3.1a Lot 32 (1324) Thomas Road, Oakford - Proposed Oat Mill Operating Facility and Associated Buildings and Structures - 'Industry-Rural' – DAP/25/02840

**Part C – Item 3.1a – LOT 32 (1324) THOMAS ROAD, OAKFORD –  
PROPOSED OAT MILL OPERATING FACILITY AND ASSOCIATED  
BUILDINGS AND STRUCTURES - ‘INDUSTRY-RURAL’**

**Form 1 – Responsible Authority Report  
(Regulation 12)**

D	29-10-2025	PROPOSED LAYOUT AMENDED	PROJECT:	1324 THOMAS ROAD, OAKFORD	DRAWN BY:	
C	19-05-2025	PROPOSED LAYOUT AMENDED	TITLE:			
B	06-12-2024	BRANDING UPDATED		BICYCLE NETWORK PLAN - 800M RADIUS	N.M.	
A	13-10-2023	ISSUED FOR REVIEW	DRAWING NUMBER:	KC01712.000_S02		
No	DATE	AMENDMENT

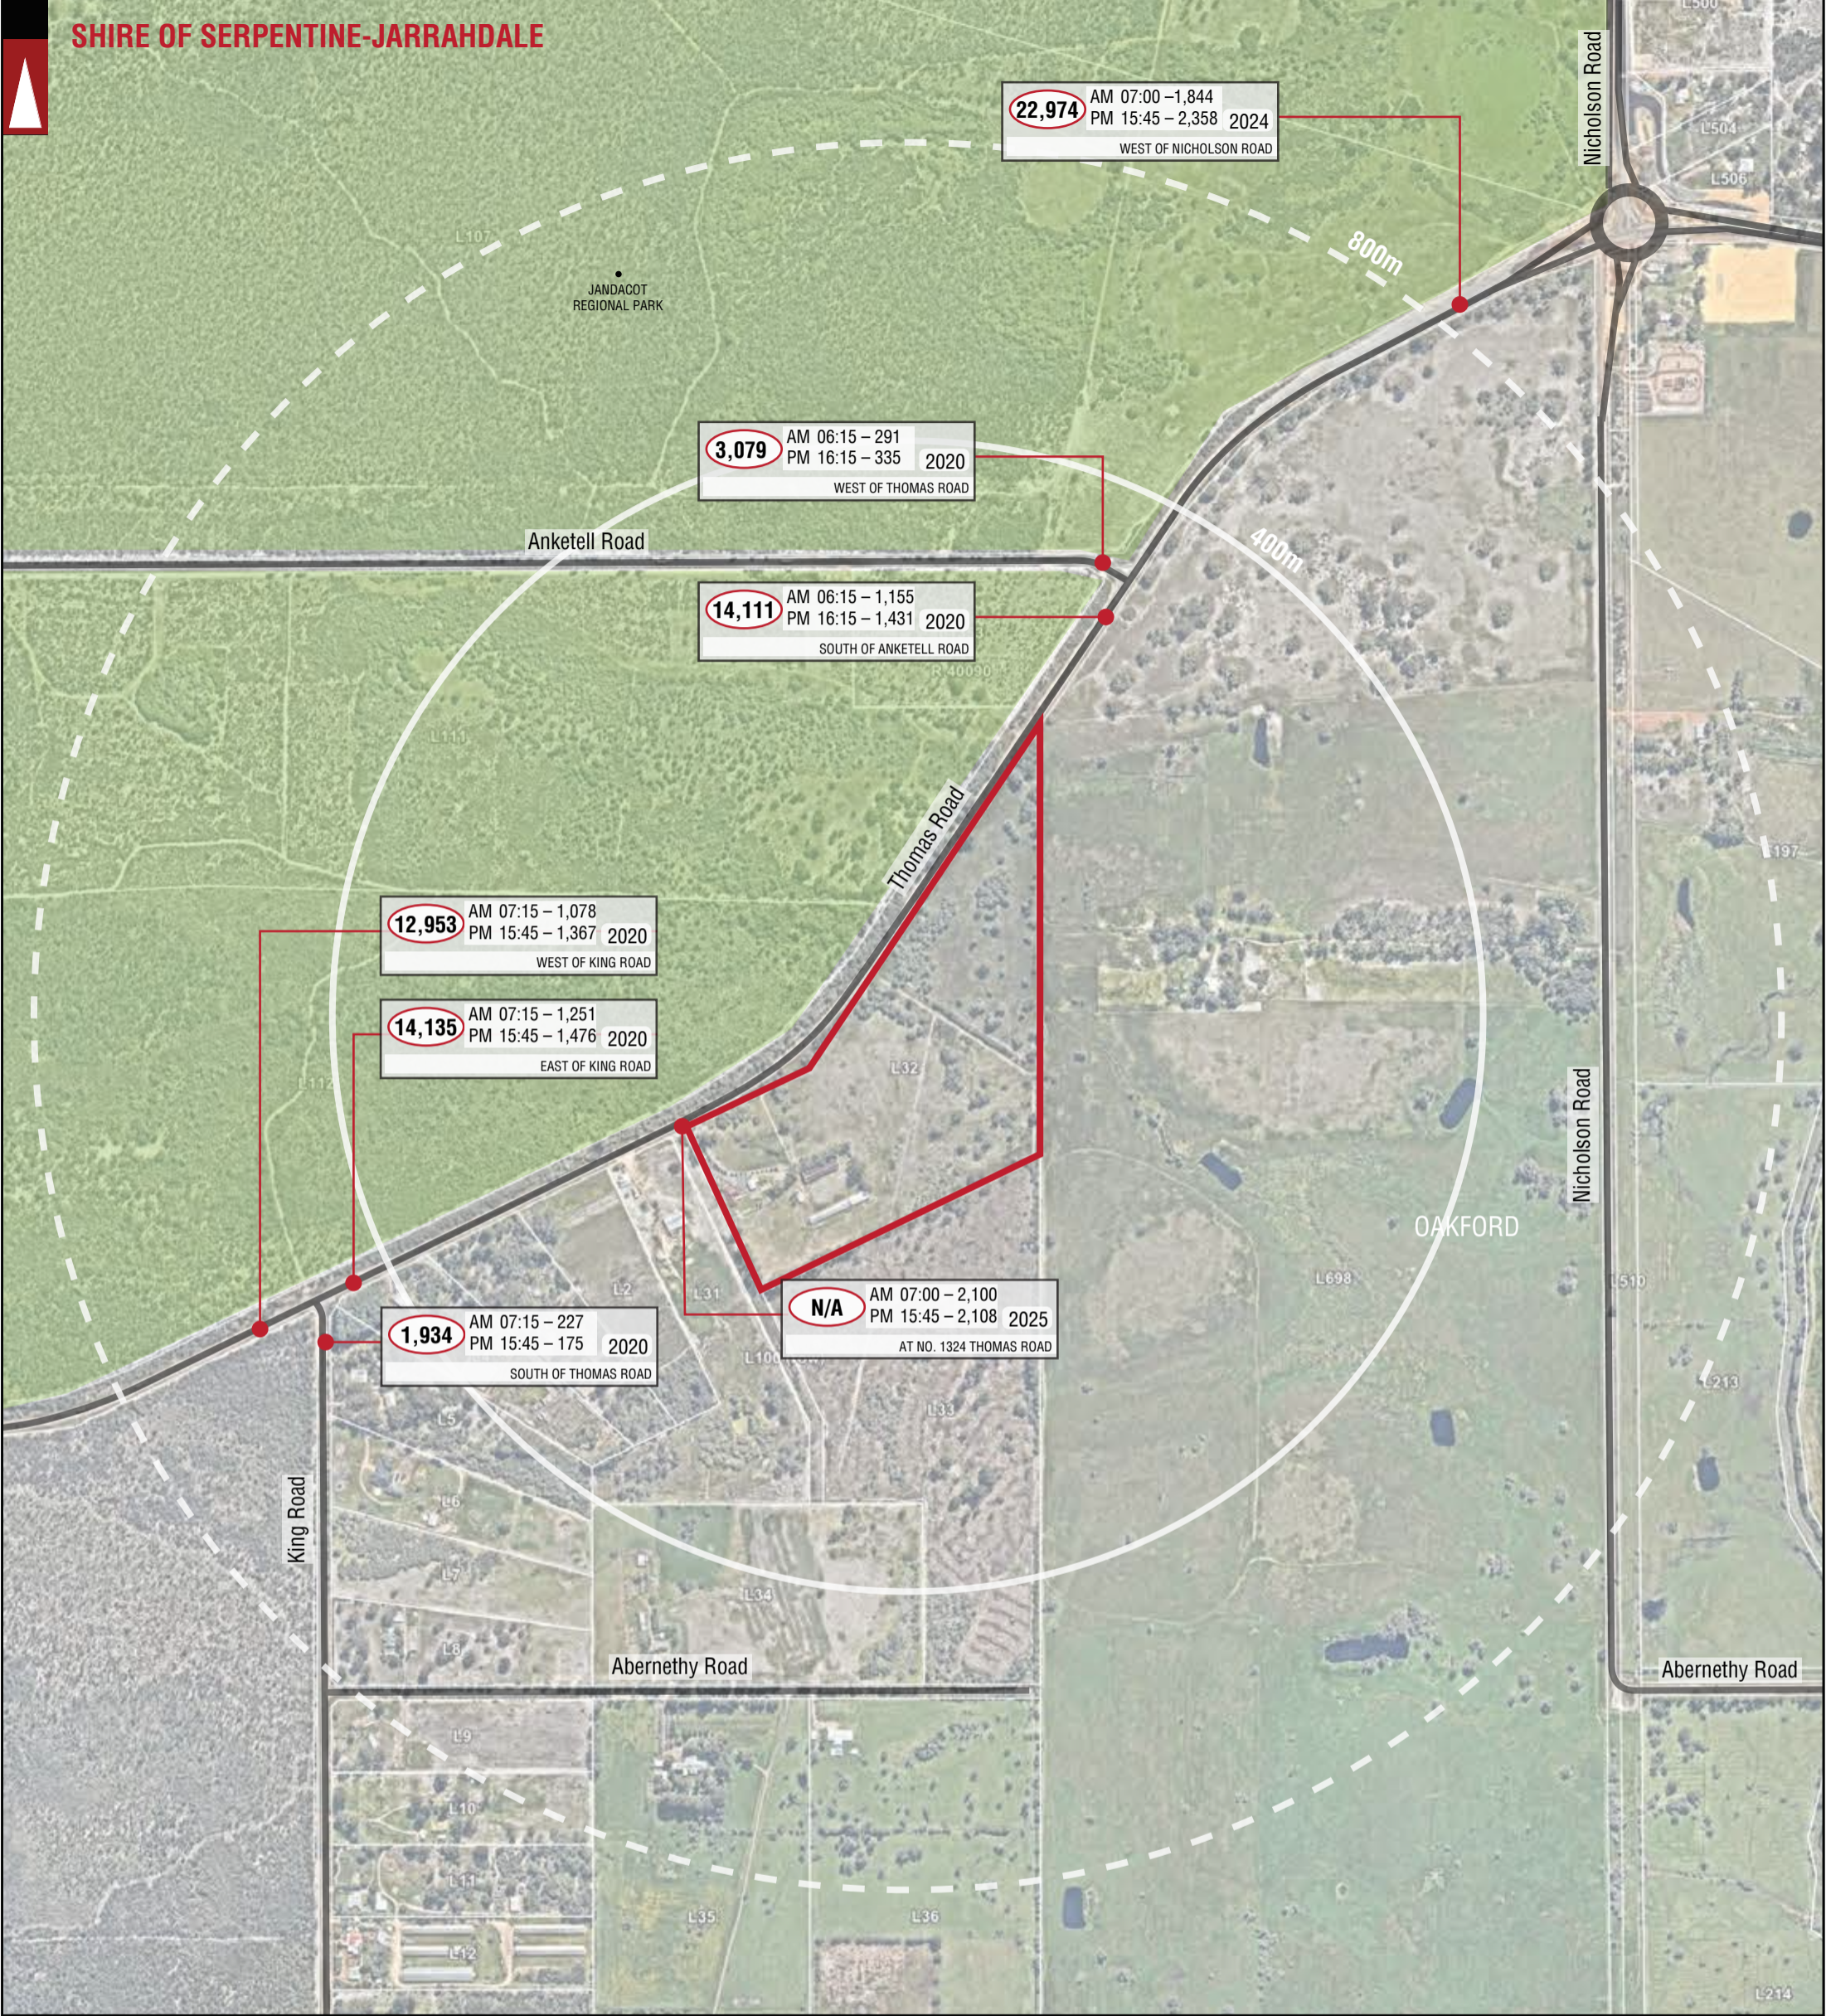
- Left-turn island angle not adjusted to 70-degrees to Thomas Road. Observation angle for left-turn exit is extremely poor and does not meet [Main Roads Supplement to Austroads Guide to Road Design – Part 4A](#), Section 6.1.3. Also refer to AGRD Part 4A, Figure C1 1 which demonstrates how vision becomes increasingly difficult at this type of observation angle.
